PRODUCT BULLETIN # 20696

Issue Date: 09-Jan-2015

TITLE: Change in inner box design.

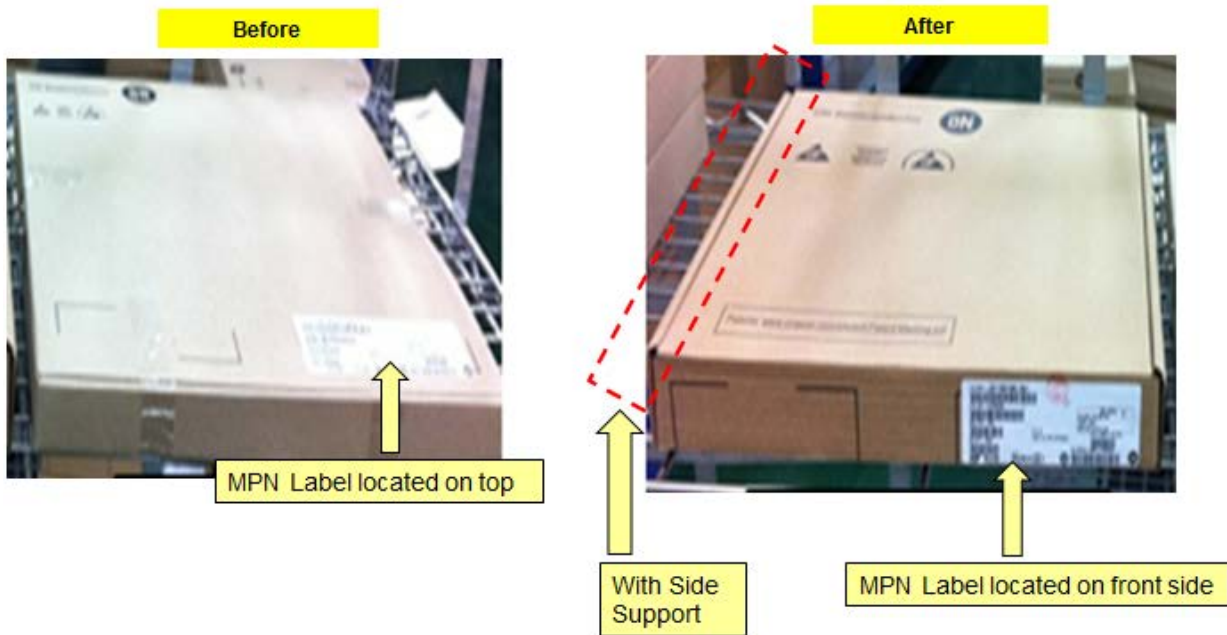
Change in Inner box design as part of the integration into the packing material of ON Semi spec.

Current				Proposed
	BOX(TE-2412)		BOX(SMP)		ON Semi Pizza Box
	Measurement	Difference	Measurement	Difference	Measurement
Length	832 mm	25 mm	863 mm	56 mm	807 mm
Width	467 mm	107 mm	491 mm	83 mm	574 mm
Height	35 mm	13 mm	47 mm	1 mm	48 mm
Actual
